Access Compliance Report

Public Rights-of-Way

(Pedestrian Signals)

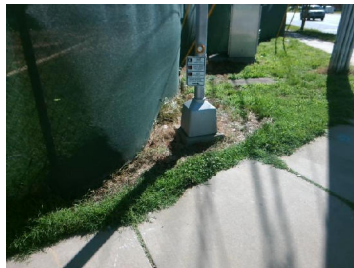
PROW/ADA: R410.6, TMUTCD 4e.08, R404.2, R404.3, R406.2, R404.7.3

Yes	B 1 Clear Xing Direction?	ClearlyMarked	N/A	B 2 Clear Xing Direction?	N/A
	B 1 Crossing Direction	To SE		B 2 Crossing Direction	N/A
Yes	B 1 DistanceTo XWalk (in)	18.0	N/A	B 2 DistanceTo XWalk (in)	N/A
No	B 1 DistanceTo Curb (in)	195.0	N/A	B 2 DistanceTo Curb (in)	N/A
Yes	B 1 Diameter (in)	2.0	N/A	B 2 Diameter (in)	N/A

Possible Solutions: Replace Signal Push Button With APS Button on New Post. Remove & Replace Sign.
